February 25, 2025

**RE: Transmittal of Technical Revision 4 for Holcim-WCR, Inc., Wattenberg Lakes Mine,
File No. M-2004-051, 112c Permit**

EXHIBIT F – RECLAMATION PLAN MAP

HOLCIM - WCR, INC.
WATTENBERG LAKES
EXHIBIT F
RECLAMATION PLAN MAP

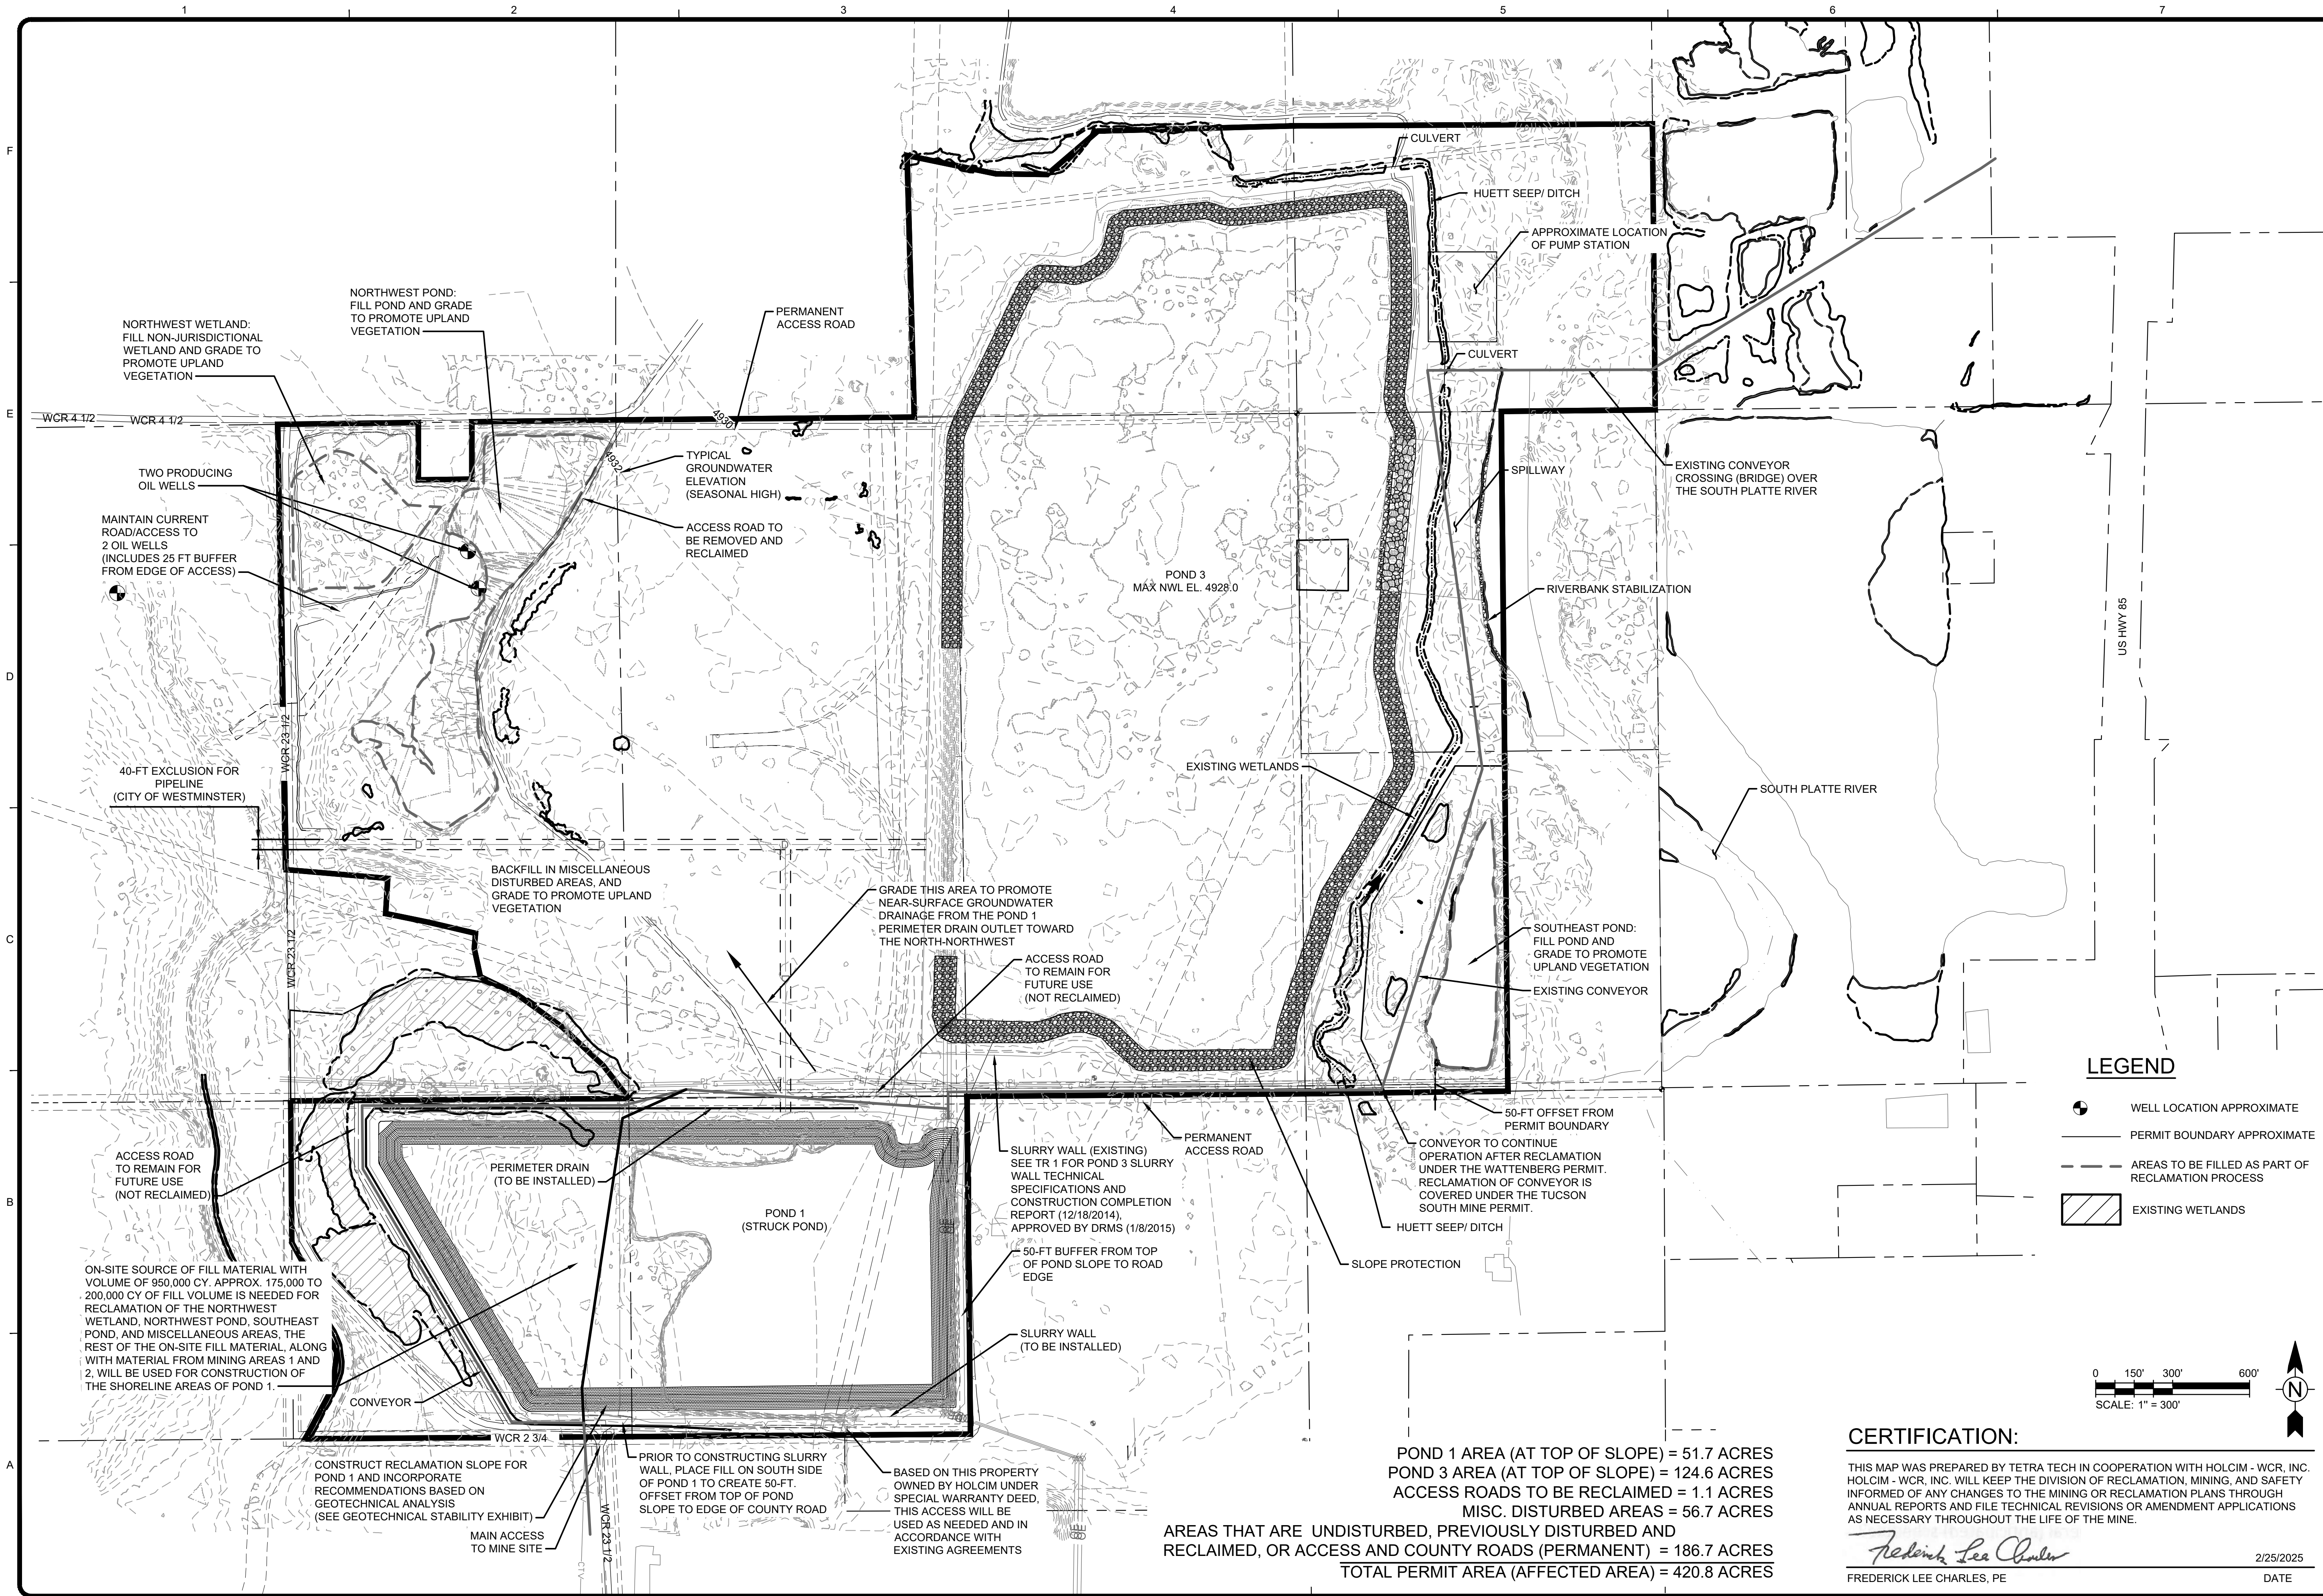
- Exhibit F (Reclamation Plan Maps): This exhibit is revised to reflect the reclamation change of TR-4.
- Exhibit G (Water Information): A revised cover page is provided that summarizes the reclamation plan change which does not require revision to Exhibit G because on-site wetland mitigation was not discussed in the most recent AM1 version (April 2024) of Exhibit G.

In general, those areas where on-site wetland mitigation was previously planned will now be reclaimed to upland vegetation. Included in this change to upland vegetation is the 10-acre cottonwood replacement area in the southeast part of the permit area that was part of the original Corps-approved on-site wetland mitigation plan as also presented in DRMS Permit Amendment AM1. With the change to off-site mitigation as discussed in the cover letter for this TR-4 submittal, cottonwood replacement was no longer required by the Corps as it is addressed as part of the bank credit purchase. Details on the amendment for the Section 404 Individual Permit are presented in the November 9, 2023 Letter from ERO to the Corps on Wattenberg Lakes Aggregate Mining Design Modifications (ERO 2023b) which is attached to this revised reclamation plan. The contents of this letter were accepted by the Corps as part of the recent Corps permit amendment.

This submittal replaces Exhibit F, submitted in April 2024 as part of Amendment 1, Wattenberg Lakes DRMS Permit No. M-2004-051.
